Amendments to the Drawings:

Fig. 13

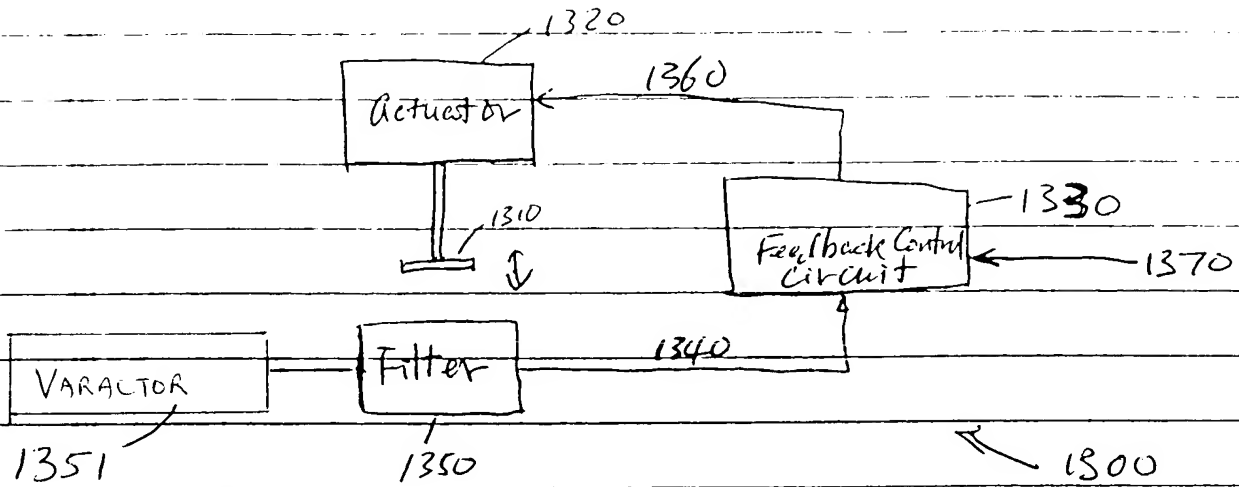
Fig. 13 has been amended. Fig. 13 now includes a functional block labeled varactor and identified by designation 1351.
